Re: Turkey Point Units 3 and 4
Docket Nos. 50-250 and 50-251
License Amendment Request No. 209
Relocation of Cycle Specific Parameters to the Core Operating Limits Report (COLR)

LICENSE AMENDMENT REQUEST NO. 209
RELOCATION OF CYCLE SPECIFIC PARAMETERS
TO THE
CORE OPERATING LIMITS REPORT (COLR)

TECHNICAL SPECIFICATIONS MARKUPS

Figure 2.1-4 Reactor Core Safety Limit—Three Loops in Operation

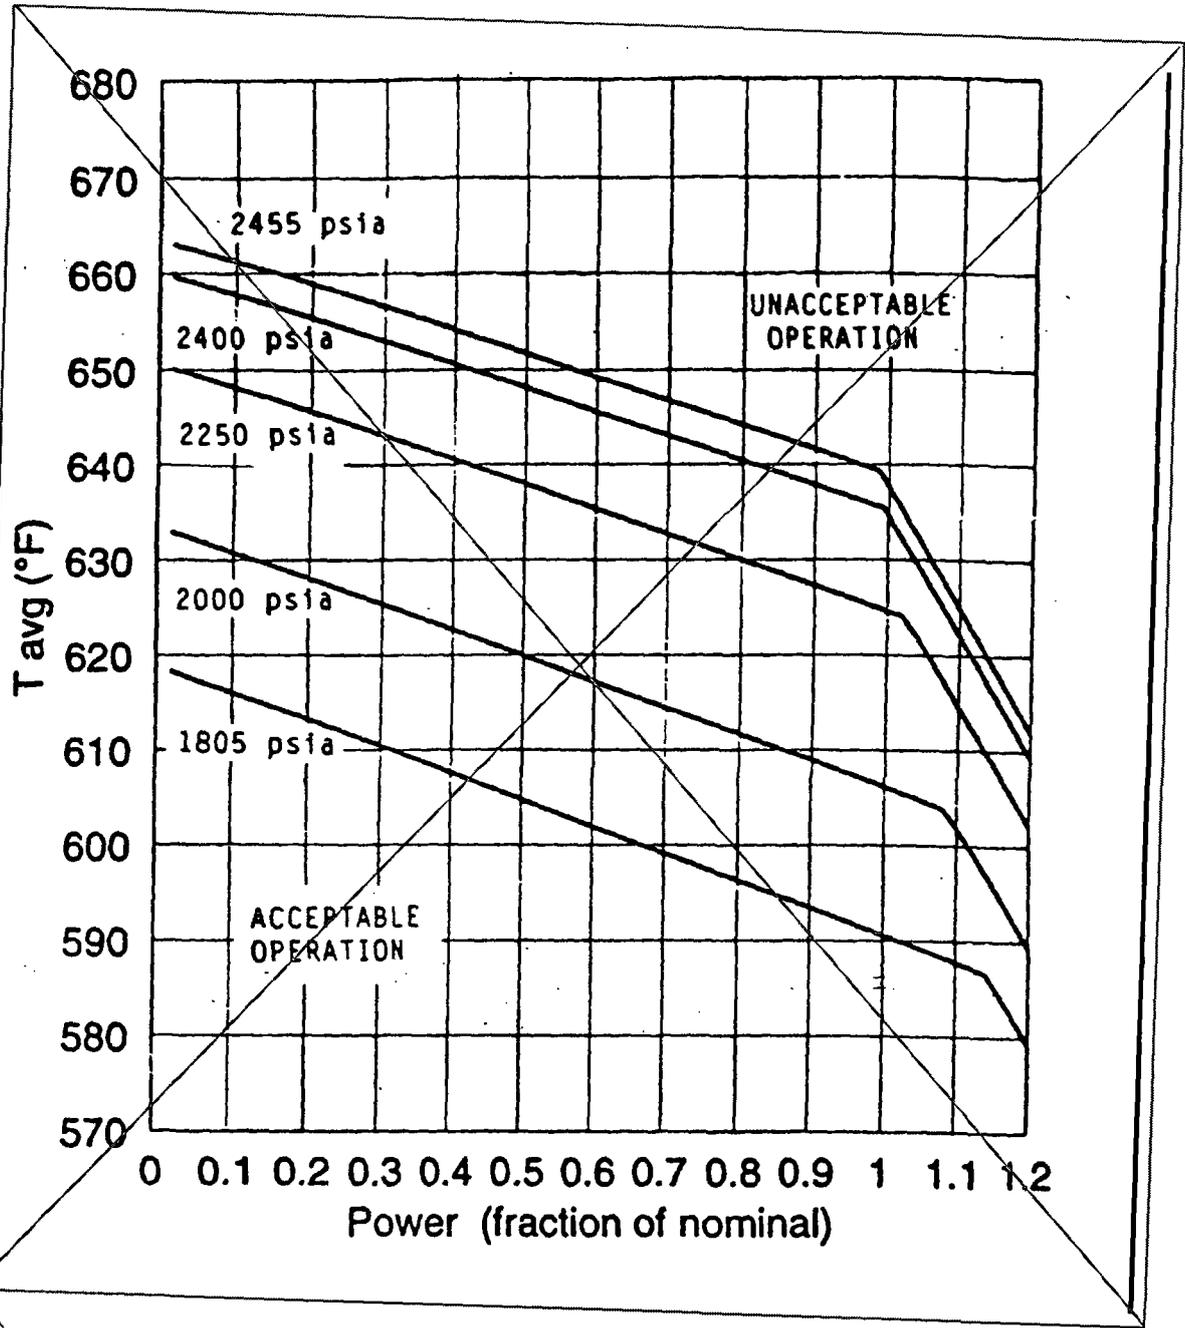
Figure 2.1-1 is being relocated from Technical Specifications to COLR.

Relocating Figure 2.1-1, "Reactor Core Safety Limit – Three Loops in Operation," to the COLR and replacing it with the fuel departure-from-nucleate-boiling (DNB) correlation design basis limit and the peak fuel centerline temperature design basis limit is consistent with the NRC Safety Evaluation for expanding the COLR as described in WCAP-14483-A (Reference 2). This relocated cycle-specific parameter is determined by the use of WCAP-9272-P-A, "Westinghouse Reload Safety Evaluation Methodology," July 1985 (Reference 4), which is listed in the PTN TS 6.9.1.7, "Core Operating Limits Report." The proposed revision of this TS is also consistent with the STS (Reference 3).

This page has been deleted

2.1.1 The combination of THERMAL POWER, pressurizer pressure, and the highest operating loop coolant temperature (T_{avg}) shall not exceed the limits **specified in the COLR**, for 3 loop operation; **and the following Safety Limits shall not be exceeded:**

a. The departure from nucleate boiling ratio (DNBR) shall be maintained ≥ 1.17 for the WRB-1 DNB correlation.

b. The peak fuel centerline temperature shall be maintained $< 5080^{\circ}\text{F}$, decreasing by 58°F per 10,000 MWD/MTU of burnup.

TABLE 2.2-1 (Continued)

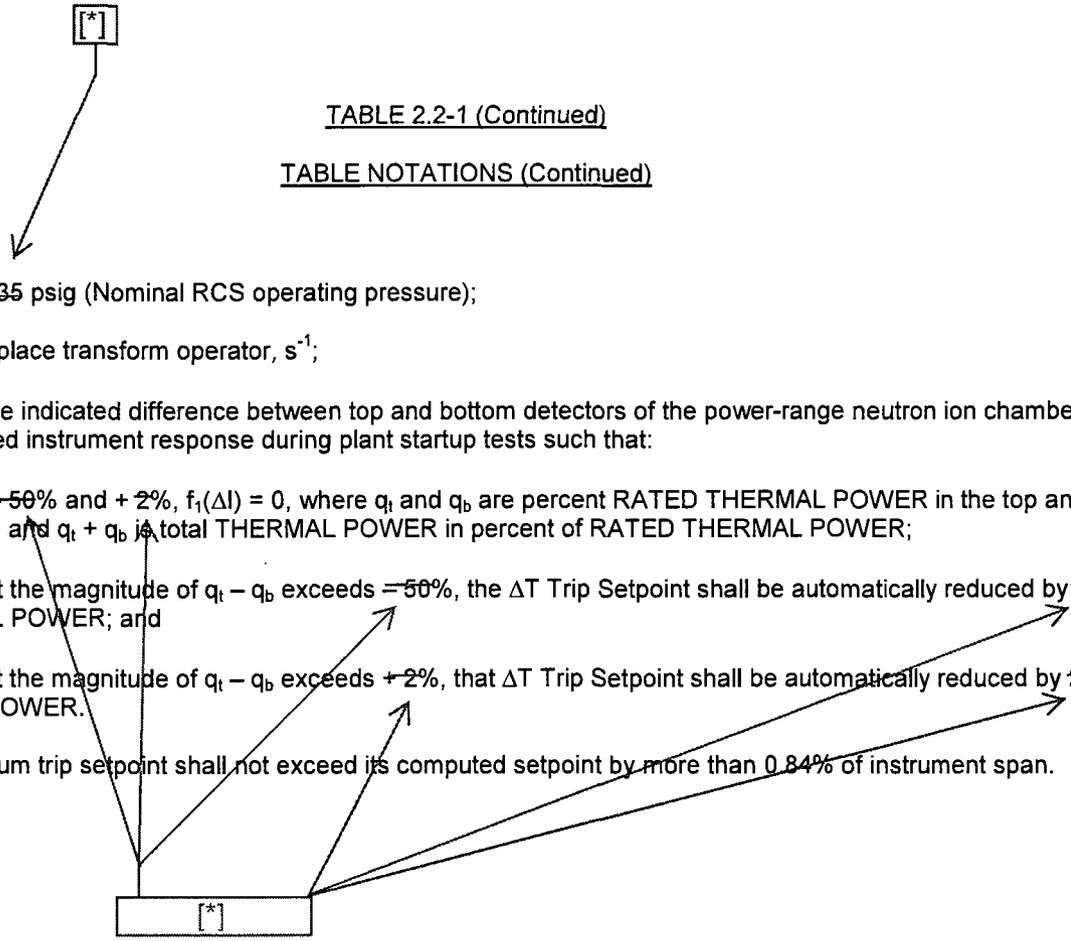
Note 1 values (K_s , τ_s , T' , P' and the breakpoint and slope values for the $f_1(\Delta I)$ function) are being relocated to the COLR. This relocation is consistent with the NRC Safety Evaluation for WCAP-14483-A (Reference 2). These relocated cycle-specific parameters are determined by the use of WCAP-8745-P-A, "Design Basis for the Thermal Overpower ΔT and Thermal Overtemperature ΔT Trip Functions," September 1986 (Reference 5) and WCAP-9272-P-A (Reference 4). The first WCAP will be listed in PTN TS 6.9.1.7, "Core Operating Limits Report" as part of this LAR. The second WCAP is already listed in the same PTN TS section. Relocation of this information to the COLR is also consistent with the STS (Reference 3).

[*]

- $K_1 = [*]$
- $K_2 = [*]^{\circ}\text{F}$
- $K_3 = [*]/\text{psig}$
- $T' \leq [*]^{\circ}\text{F}$ (Nominal T_{avg} at Rated Thermal Power)
- $P' \geq [*]\text{psig}$ (Nominal RCS operating pressure)
- $\tau_1, \tau_2, \tau_3, \tau_4, \tau_5, \text{ and } \tau_6 = [*]\text{sec}$
- $f_1(\Delta I)$, item (1), "For $q_t - q_b$ between - [*]% and + [*]%, ..."
- $f_1(\Delta I)$, item (2), "... $q_t - q_b$ exceeds - [*]% ... automatically reduced by [*]% ..."
- $f_1(\Delta I)$, item (3), "... $q_t - q_b$ exceeds + [*]% ... automatically reduced by [*]% ..."

TABLE 2.2-1 (Continued)

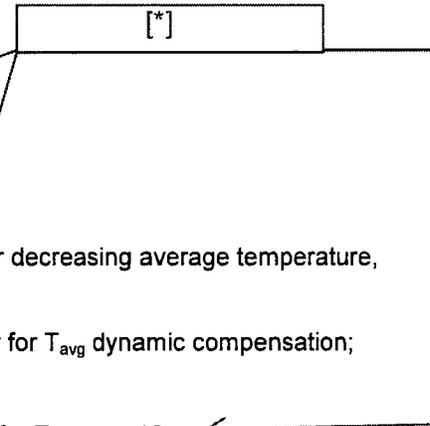
Note 3 values (K_s , τ_7 , T'' and $f_2(\Delta I)$) are being relocated to the COLR). This relocation is consistent with the NRC Safety Evaluation for WCAP-14483-A (Reference 2). These relocated cycle-specific parameters are determined by the use of WCAP-8745-P-A (Reference 5) and WCAP-9272-P-A (Reference 4). The first WCAP will be listed in PTN TS 6.9.1.7, "Core Operating Limits Report" as part of this LAR. The second WCAP is already listed in the same PTN TS section. Relocation of this information to the COLR is also consistent with the STS (Reference 3).

- $K_4 \leq [*]$
- $K_5 \geq [*/^\circ\text{F}]$ for increasing average temperature
 $\geq [*/^\circ\text{F}]$ for decreasing average temperature
- $K_6 = [*/^\circ\text{F}]$ for $T > T''$
= $[*/^\circ\text{F}]$ for $T \leq T''$
- $T'' \leq [*/^\circ\text{F}]$ (Nominal T_{avg} at Rated Thermal Power)

- $\tau_7 \geq [*]\text{sec}$
- $f_2(\Delta I) = [*]$

Figure 3.1-4
 Required Shutdown Margin vs Reactor Coolant
 Boron Concentration

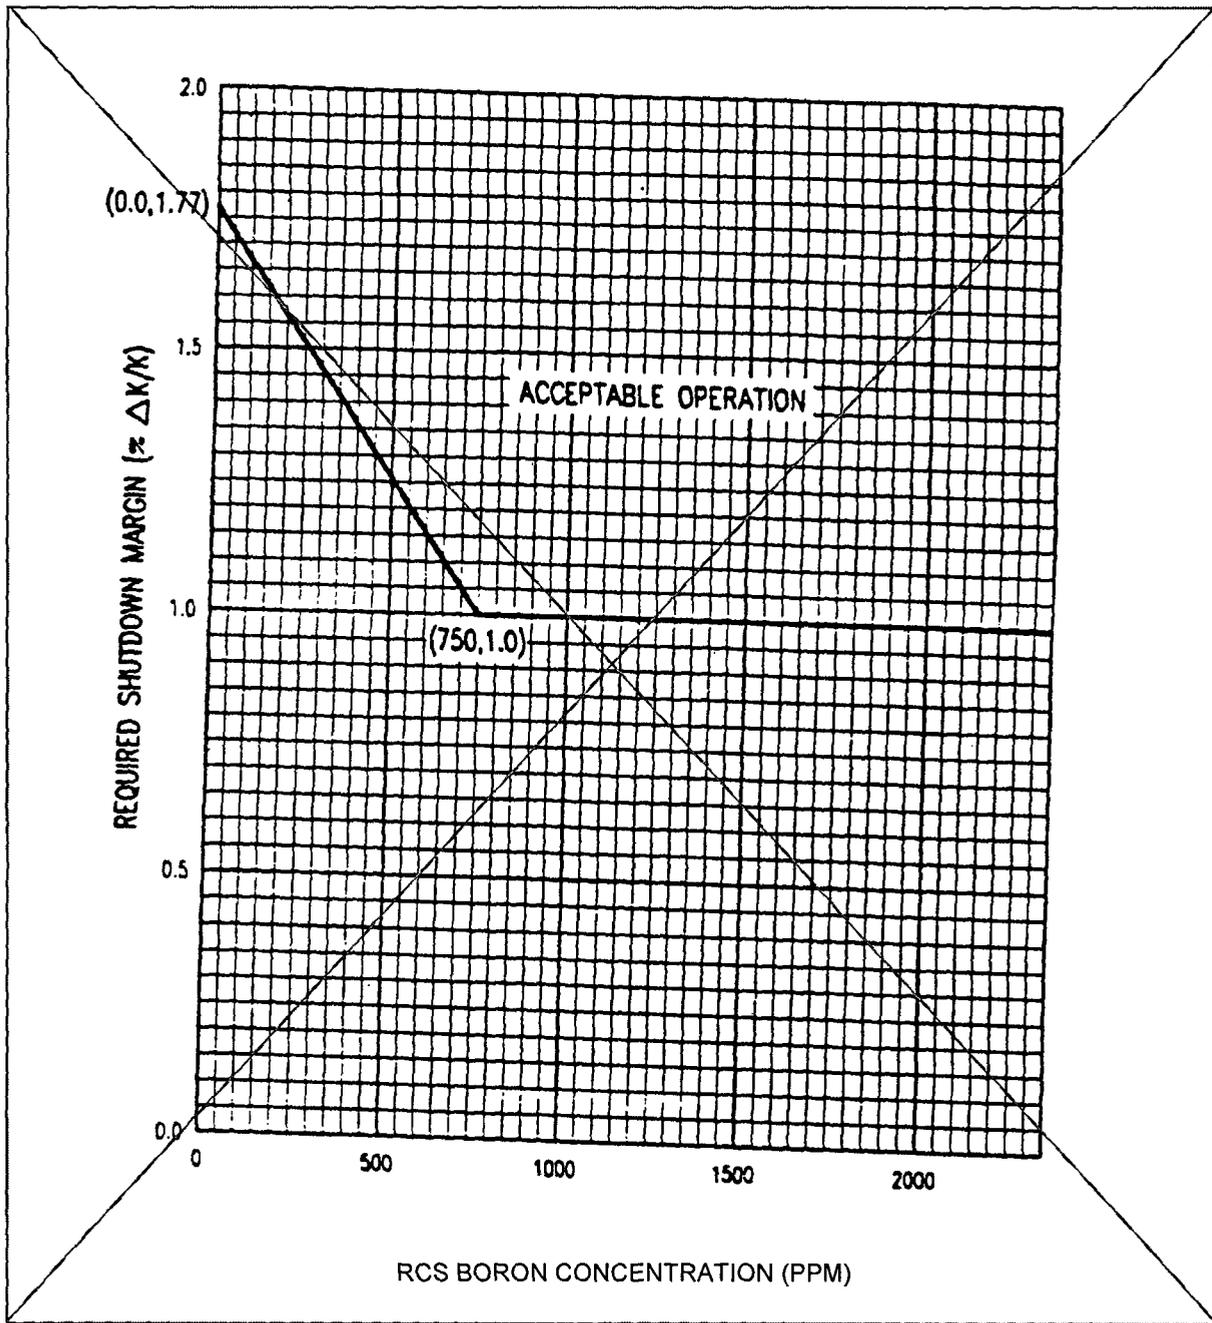
Figure 3.1-1 is being relocated from Technical Specifications to COLR.

For this specification, Figure 3.1-1, "Required Shutdown Margin vs Reactor Coolant Boron Concentration" is relocated to the COLR. This change is consistent with the guidance provided in the STS (Reference 3) for relocating shutdown limits to the COLR. This relocated cycle-specific parameter is determined by the use of WCAP-9272-P-A (Reference 4) which is listed in the PTN TS 6.9.1.7, "Core Operating Limits Report." The reference to this figure in LCO 3.1.1.1, associated ACTION, and SR 4.1.1.1.1 are also revised to be consistent with the relocation of this figure to the COLR.

This page has been deleted

LCO 3.1.1.1.1: The SHUTDOWN MARGIN shall be **within the limits specified in the COLR.**

SR 4.1.1.1.1 The SHUTDOWN MARGIN shall be determined to be within the limits specified in the COLR.
